Planning Commission Minutes
October 24, 2024

22. (PUD-2030) Application by Skyline River Front, LLC and Exchange Avenue Properties, LLC to rezone 1501 Exchange Avenue from I-2 Moderate Industrial, I-3 Heavy Industrial, SPUD- 827 Simplified Planned Unit Development, and SRODD Scenic River Overlay Design Districts to PUD-2030 Planned Unit Development, and SRODD Scenic River Overlay Design Districts. Ward 6.

STAFF REPORT
The City of Oklahoma City
Planning Commission
October 24, 2024

STAFF REPORT

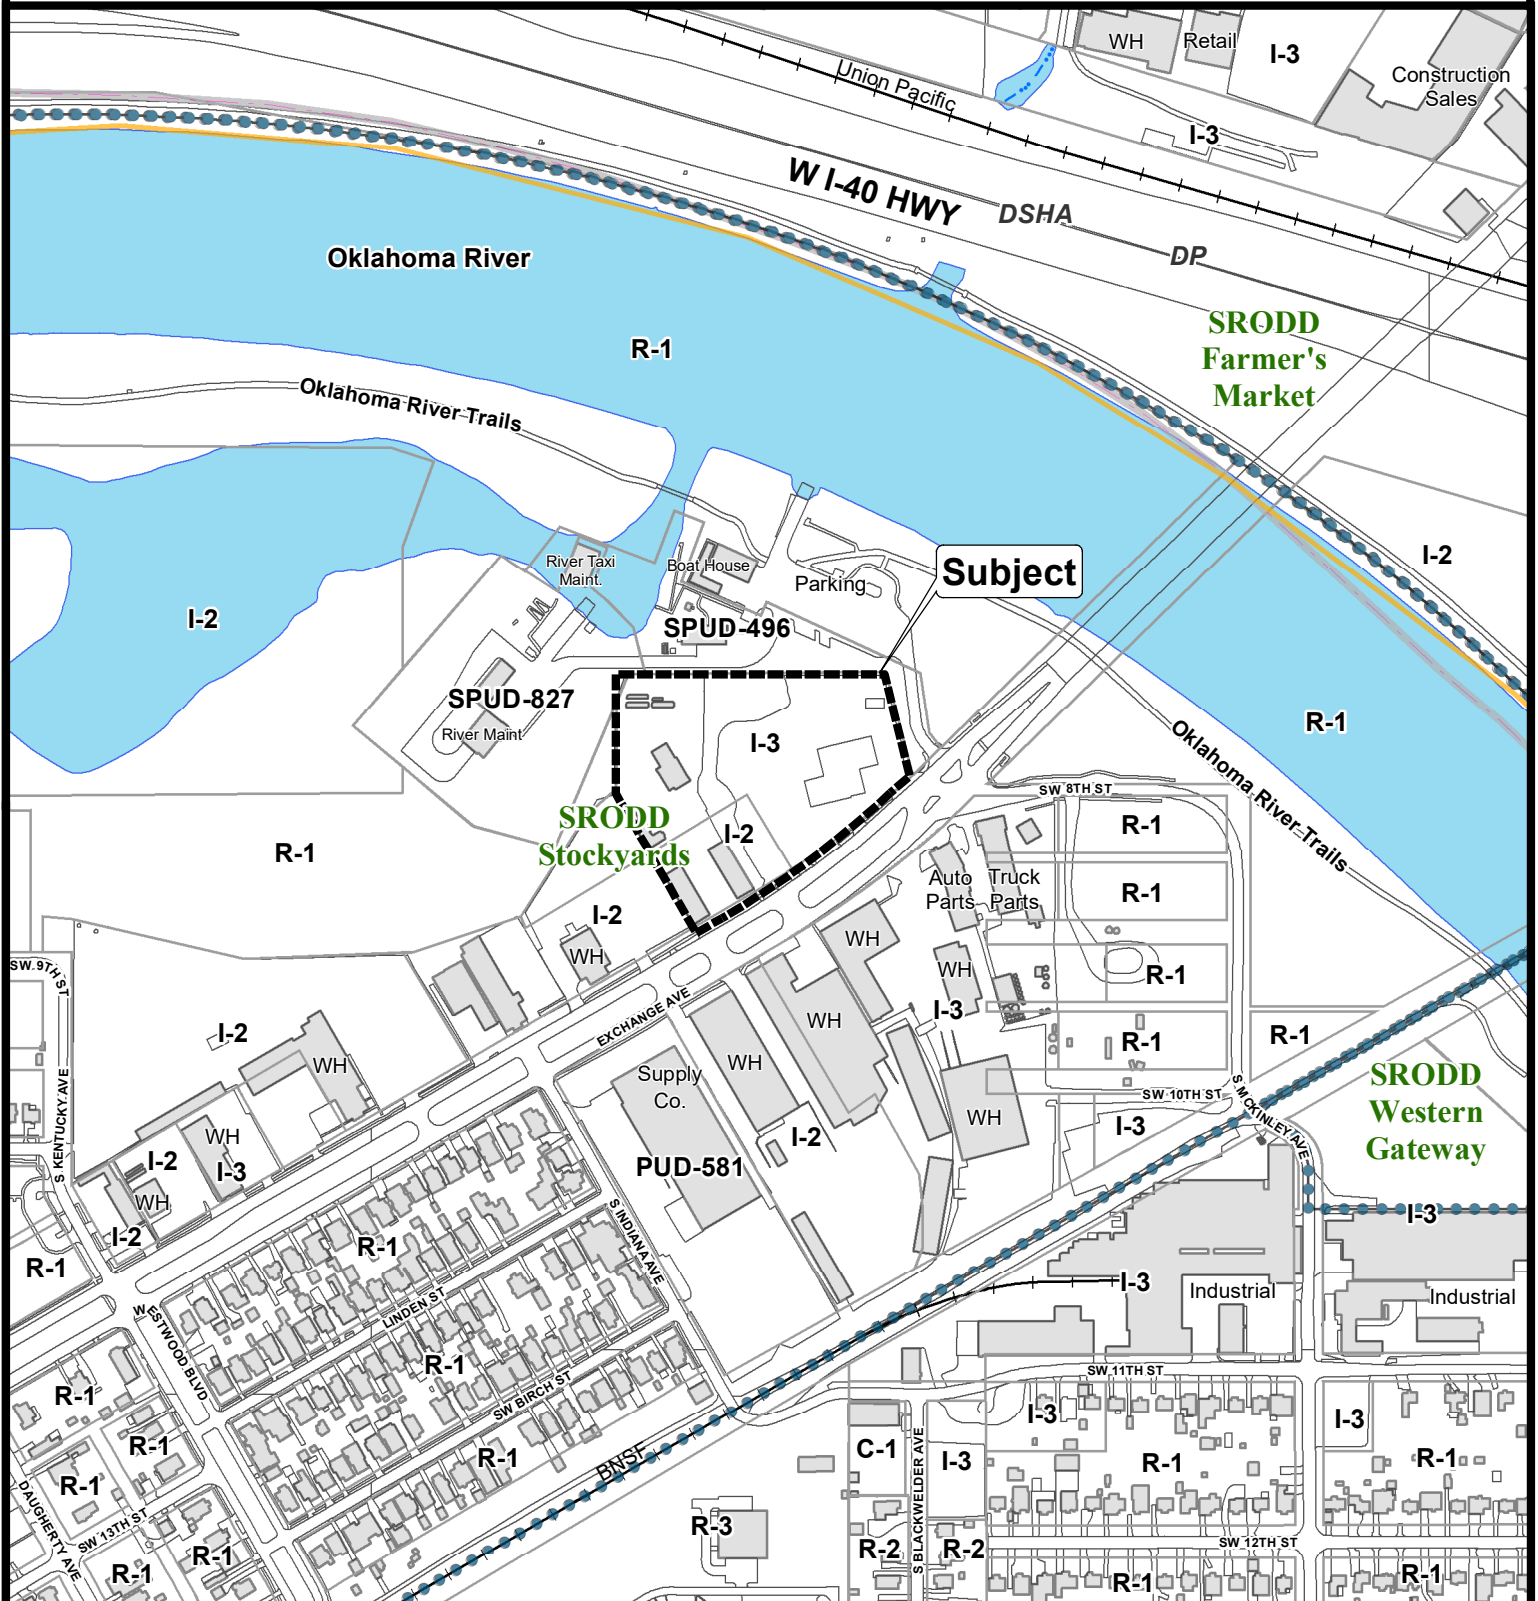
- a. **RE: Landscaping**

- 1) Description: The applicant has not provided adequate spacing/setbacks along the Exchange Ave project frontage to provide the room necessary for the required street trees.
- 2) Reference: §13500.5.J.(2)(a)2.i., Landscaping and Screening Regulations

- 3) Considerations: The bulk regulations contained in the MDS for this project specify a 10 foot setback along the north side of Exchange Ave. This means that the space between the fence proposed along Exchange Ave and the first structures located inside that fence could be as little as 10 feet. There is already an underground water line located in this setback area along Exchange Ave. Trees need to be spaced a minimum of at least 10 feet away from a water line.

In order to ensure that there is enough room to plant the required street trees a minimum distance from the existing water line, and that there is adequate room for them to grow between the boundary fencing and the proposed residential structures, staff recommends that the minimum setback along Exchange Ave be changed from 10 feet to 25 feet.

1. **Provide a recommendation of approval to the Planning Commission** on the application for a request to rezone from I-2 and I-3/SRODD to Planned Unit Development (PUD-2030) on the basis that the project complies with the intent of the Scenic River Overlay Design District zoning ordinance as reference in Section C and D of the Staff Report with the condition that:
 - a. The applicant shall revise the MDS for PUD-2030 to make the required setback along Exchange Ave 25 feet.

**PUD-2030 Exhibit B -
Master Development Plan**

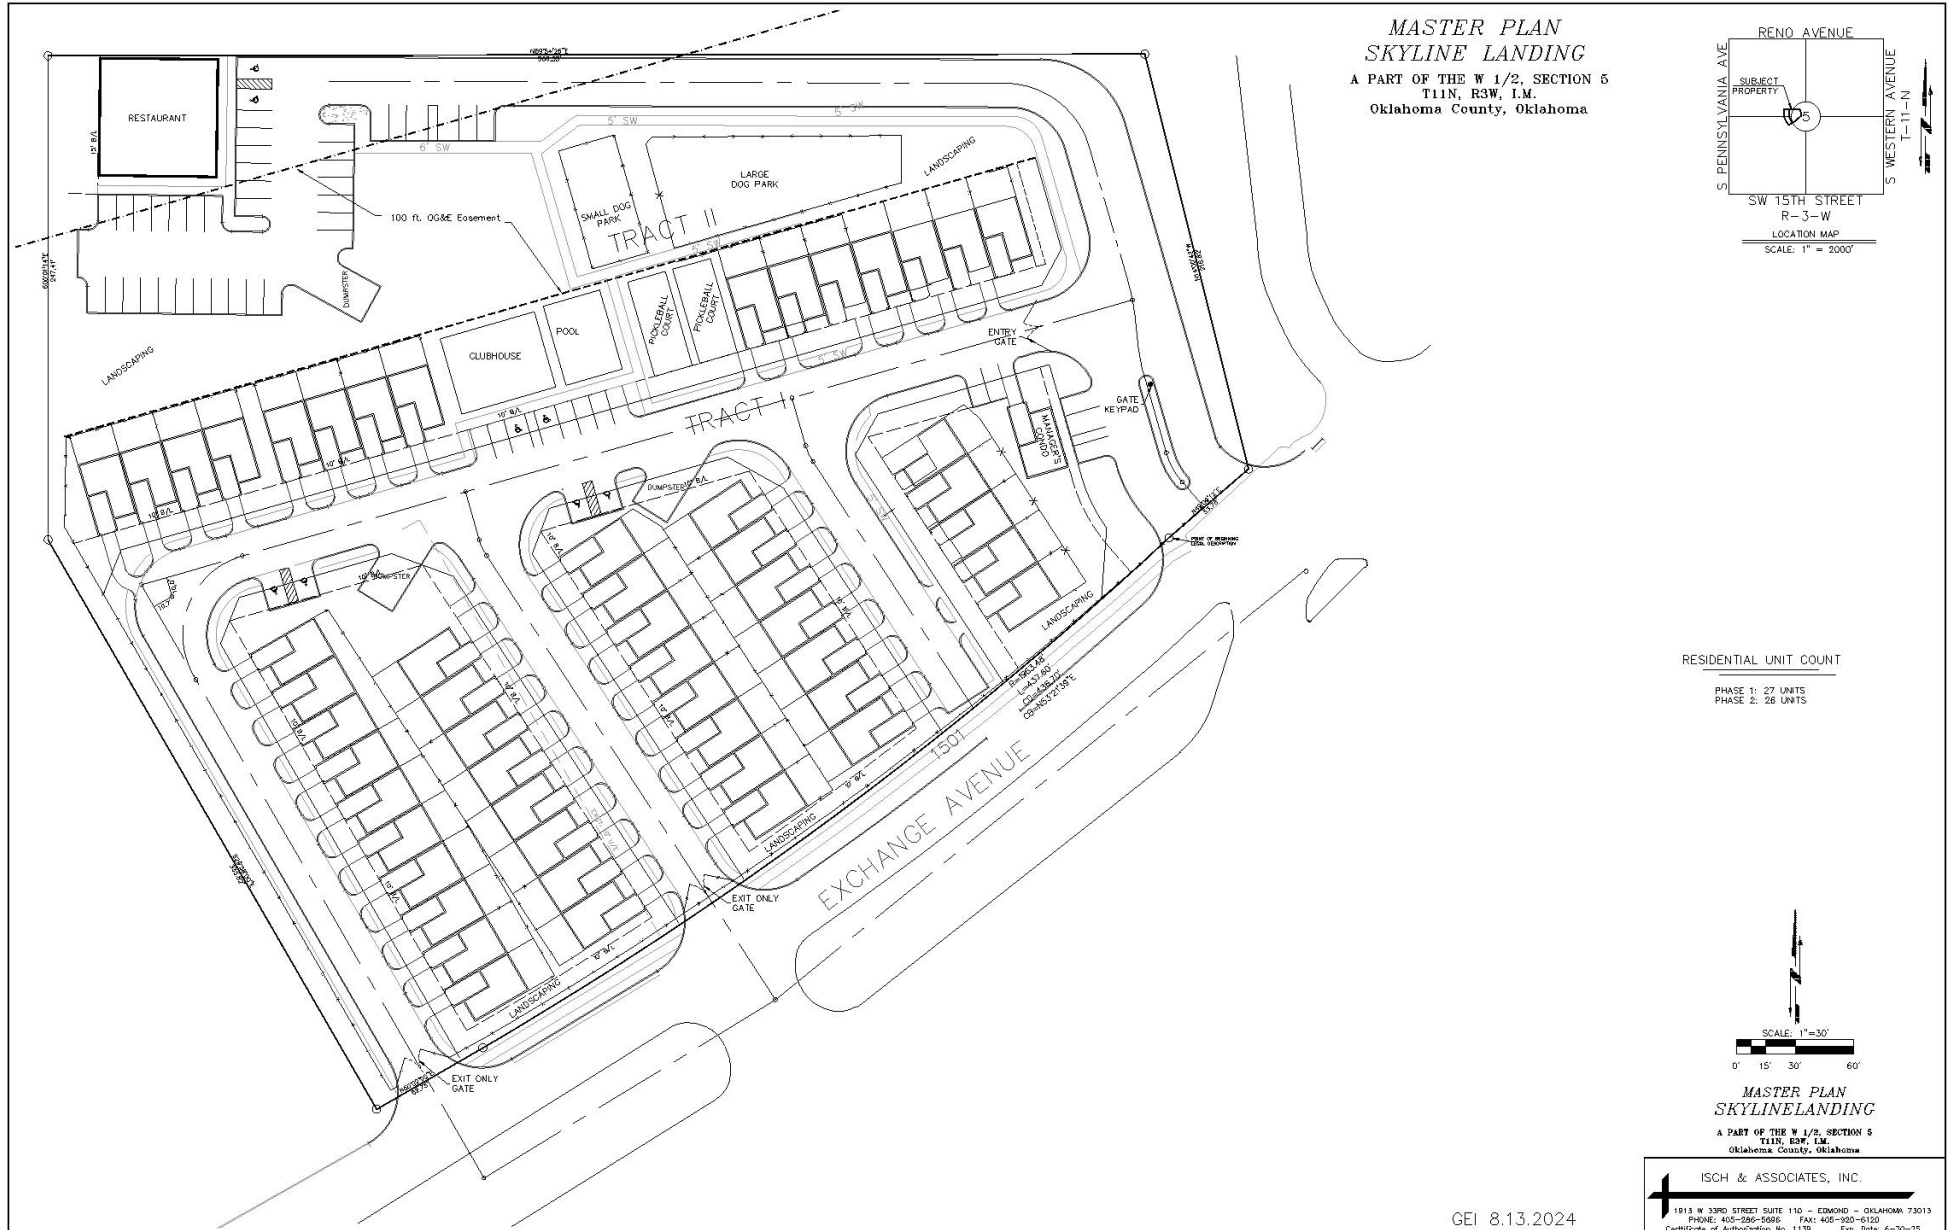
- 16) Exchange Avenue is shown on the Functional Classification Plan as a Major Arterial. Revise minimum driveway spacing to 200 feet.
- 17) The Master Development Plan shows 3 drives onto Exchange Avenue. Revise the Master Development Plan to show only 2 drives to make it consistent with the PUD language. *[Revised by applicant to allow three drives]*
